SERVICE BULLETIN

B-014

SAFETY RECALL CODE 0808 -TURN SIGNAL FLASHER

Figure 1. Turn Signal Wires

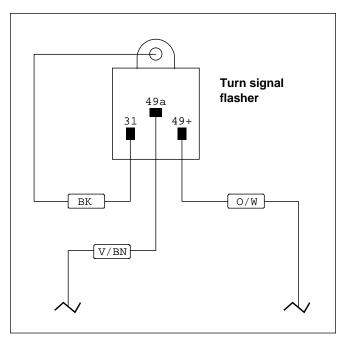
- Remove seat, tail section and frame heat shield (if equipped). Refer to the appropriate Service Manual for specific instructions if necessary.
 - a. S1/S1W models, Part No. 99490-98Y (information applies to all model years).
 - b. M2 models, Part No. 99491-98Y.
 - c. S3/S3T models, Part No. 99489-98Y.
- 2. Remove 1/4-20 allen head screw which secures turn signal flasher clamp to frame.
- 3. Detach wiring from turn signal flasher. Discard turn signal flasher and clamp.
- 4. See Figure 1. Attach wiring to **new** turn signal flasher. Terminal numbers are marked on bottom of flasher.
 - a. Connect violet/brown wire to terminal 49a.
 - b. Connect orange/white wire to 49+.
 - c. Connect black ground wire to 31.

Figure 2. Flasher Mounting

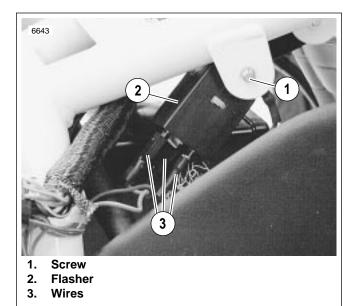
- 5. Mount **new** turn signal flasher to inside of frame tube as shown in Figure 2.
 - a. Place 1/4-20 allen head screw through ring terminal in ground wire.
 - b. Continue through flasher mount tab into backside of frame tab. Tighten securely.
